| This ASB revises ASB-912-061UL dated 26 May 2012

ALERT SERVICE BULLETIN

Replacement of the pressure side fuel hose at fuel pump part no. 893114 for ROTAX® Engine Type 912 (Series)

ATA System: 73-00-00 Fuel system

Fig. 1
Fuel pump

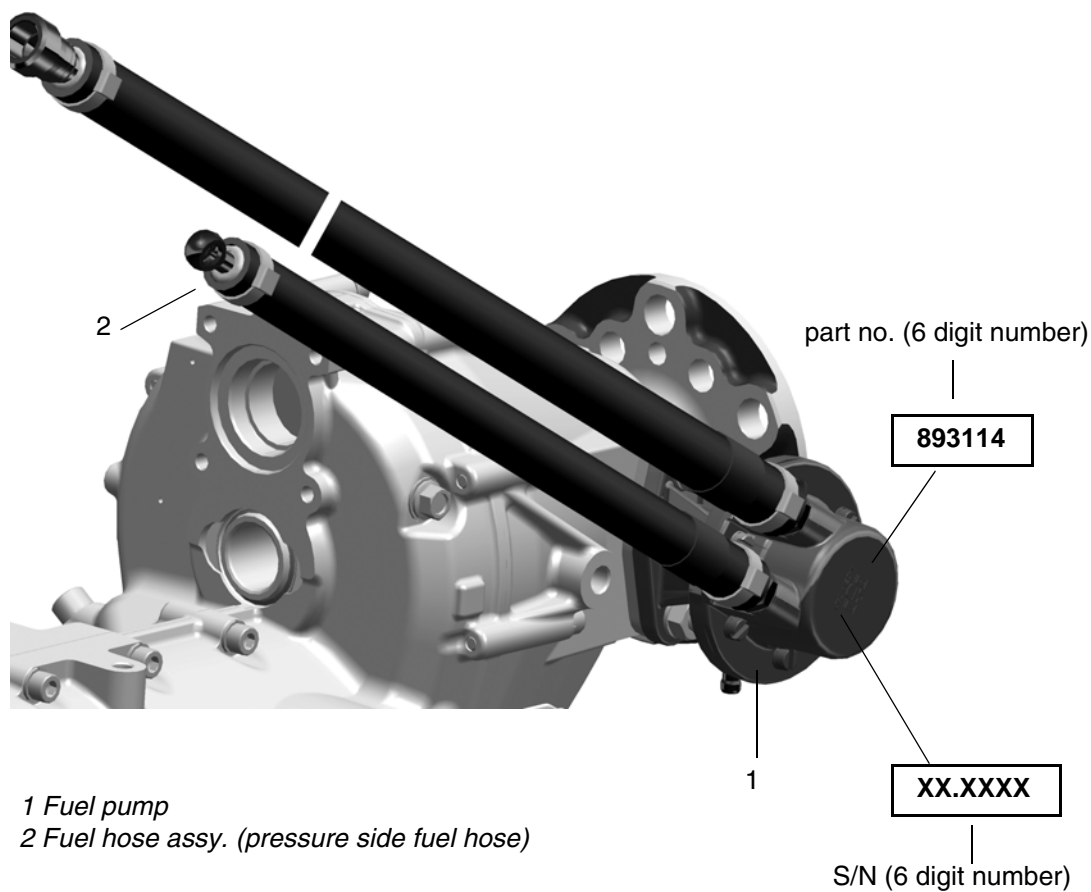
if they are equipped with the genuine ROTAX® fuel pump part no. 893114.
See [Fig. 1](#)

Fig. 2
Carburetor, Fuel pump

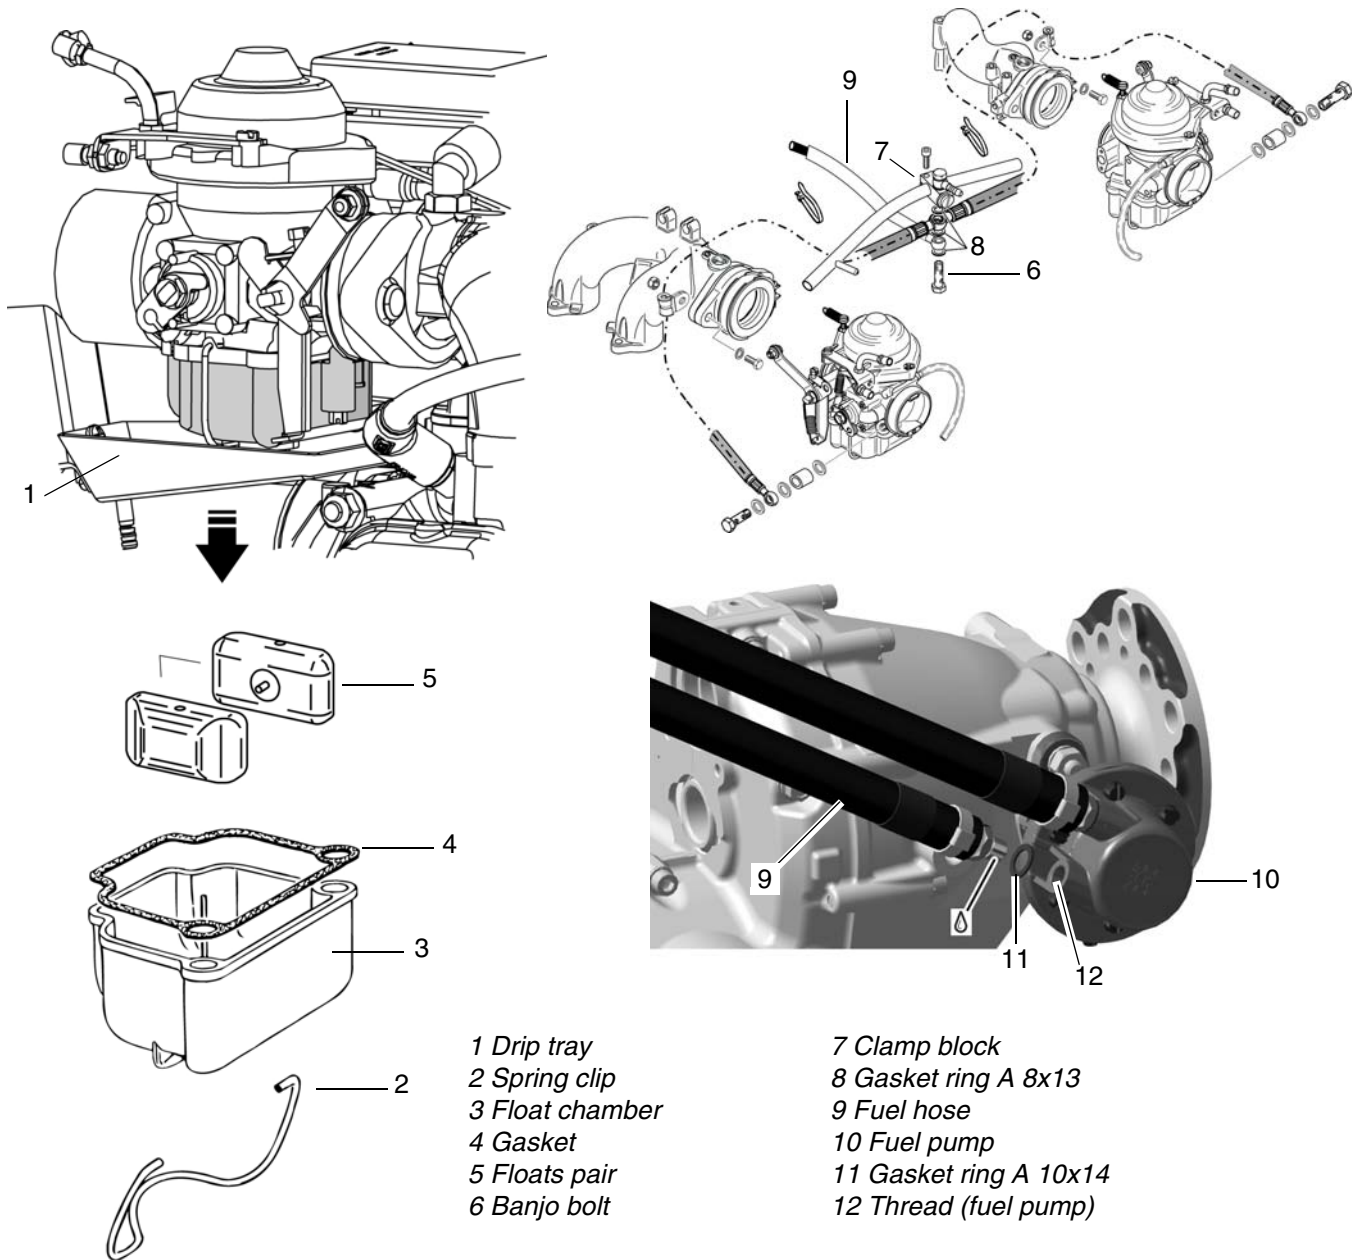
3.2) Replacement of the fuel hose assy. part no. 874335

Step	Procedure
1	Remove banjo bolt (6) from clamp block (7) together with 3 gasket rings (8).
2	Remove the fuel hose (9).
3	Remove the fuel hose (9) from the fuel pump (10) together with gasket ring (11).

Step	Procedure
1	Inspection of the thread (12) from the fuel pump and remove possible sealing materials.
2	Clean and degrease thread (12) of the fuel pump.

Fig. Pos. no.	New part no.	Qty/ engine	Description	Old part no.	Application
2, 9	874336	1	Fuel hose assy.	874335	Fuel pump assy. part no. 893114 (pressure side)
11	250425	1	Gasket ring A10x14	230150	Fuel hose
8	-	3	Gasket ring A8x13/0.8	950143	Clamp block

Step	Procedure
1	Install the new fuel hose (9) and new gasket ring A 10x14 (11) with LOCTITE 243 on the fuel pump. Tightening torque 10 Nm (90 in.lb).
2	Install fuel hose (9) and the banjo bolt (6) with new gasket ring (8) on the clamp block (7). Tightening torque of banjo bolt (6) 10 Nm (90 in.lb). Check that the fuel hose is not under strain or tension.
